TECHNICAL BULLETIN

[Issue No.] T12-0017

[Title] Errors in writing in Type QD75P/QD75D Positioning Module User's Manual

< Positioning start program example described in User's Manual (before correction) >

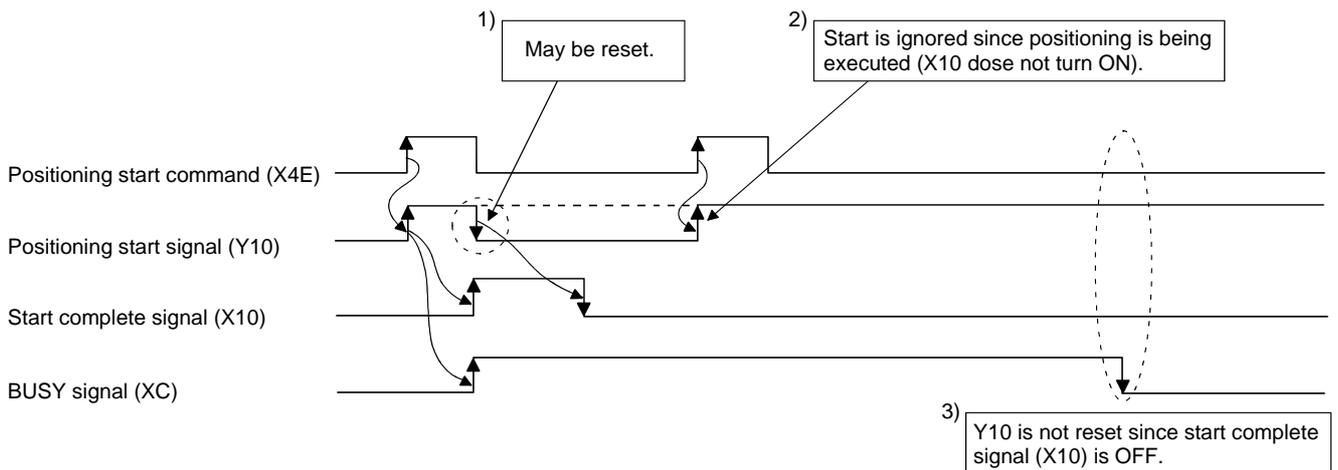
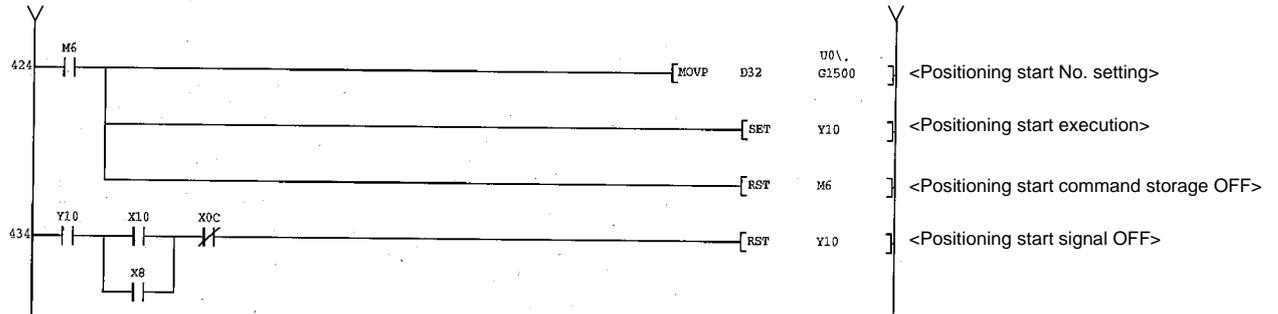
Correct the reset condition of the positioning start signal (Y10) as shown below.

- 1) When the BUSY signal is not the direct access input (DXC), the positioning start signal (Y10) may be reset immediately after start complete (X10 ON). (Normally, it is reset when the BUSY signal (XC) turns OFF after positioning complete.)
- 2) If reset, the positioning start signal (Y10) can be turned ON when the positioning start command (X4E in the program example) is turned from OFF to ON again, even though positioning is being executed. (Although Y10 cannot be turned ON under normal circumstances)
However, if the positioning start signal (Y10) is turned ON, a start is ignored and the start complete signal (X10) does not turn ON.
It is because the positioning module detects Warning 100 (start during operation).
- 3) Since the start complete signal (X10) is OFF, the positioning start signal (Y10) is not reset. And the next positioning does not start.
